497 COALING STATION 6-14107

**Fix for improper dump car activation during load function and/or no Post
War #3459/3469 Coal Dump Car Operation on the
No. 497 Coaling Station 6-14107**

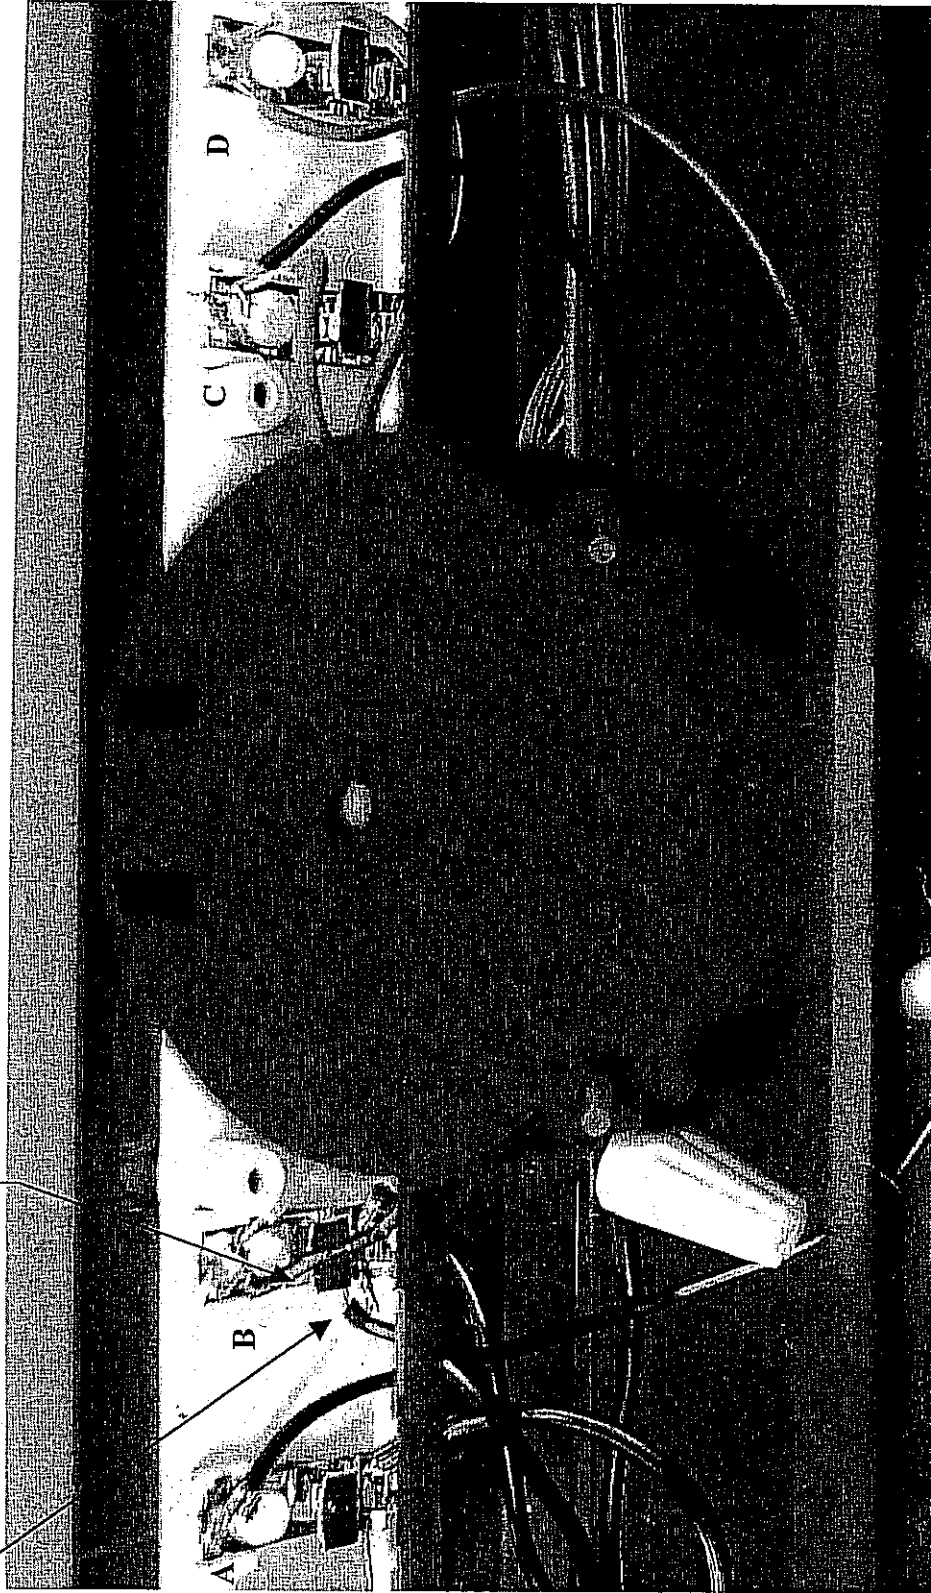
THE BLACK WIRE
COMING UP
THRU THE BIN FROM
THE LOADING
SOLENOID

WIRE #4 FROM THE
REMOTE CONTROL TRACK

MOVE THE 2-LABELED BLACK WIRES FROM
TERMINAL B TO TERMINAL A. SEE INSTRUCTION
SHEET FOR COMPLETE DETAILS

Problem The dump car is being activated and dumping when the "LOAD" function is activated. The Post-War dump cars will not work.

Cause Incorrect wiring at the terminal strip inside the coal bin.

Fix Place the station in front of you so that with the roof off and the coal tray in the lowered position you can see the white terminal strip mounted on the rear of the bin.

Starting from the left side of the strip and moving to the right you will see terminal A, then terminal B, next you will see the motor, then terminals C and D. We will be working on terminals A and B only.

We will be repositioning two wires, the first wire can be found by looking right below the motor/gearbox and you will see 2 black wires from the loading solenoid coming thru a hole in the bottom of the bin between the 2 coal chutes. Follow the wires back to the terminal strip and you will find that one is attached to terminal C which is correct and no further action is required. The other wire will trace back to terminal B. This wire must be disconnected either by unsoldering or cutting it off from the terminal. Use caution as several other wires must remain on the terminal, and excessive soldering iron heat can damage the terminal strip. The wire then has to be connected onto terminal A. The wire can be soldered onto the terminal or preferably the wire end can be stripped back and inserted into the spring clip portion of terminal A.

The second wire comes from the black 4-wire cable that is wired to the remote control track section. The terminals on the track section are marked 1-4. We will call the wires attached to them wire #1,2,3,4 respectively. **NOTE!** To help identify wire #4 look at the black 4-wire cable closely and you will see that wire #1 has a raised ridge or "tračce" molded into it. The wires then follow in order as #2, #3, and the last wire across the cable is wire #4. Follow wire #4 that is

attached to terminal #4 on the track section up to terminal B in the bin. You will note that a second wire from the cable, wire #2 is also attached to terminal B.

You will find that these 2 wires are soldered together and are inserted into the clip portion of terminal B.. Cut off wire #4 leaving wire #2 in the clip.

Now take wire #4 and also attach it to terminal A on the terminal strip in the same manner as you attached the previous wire.
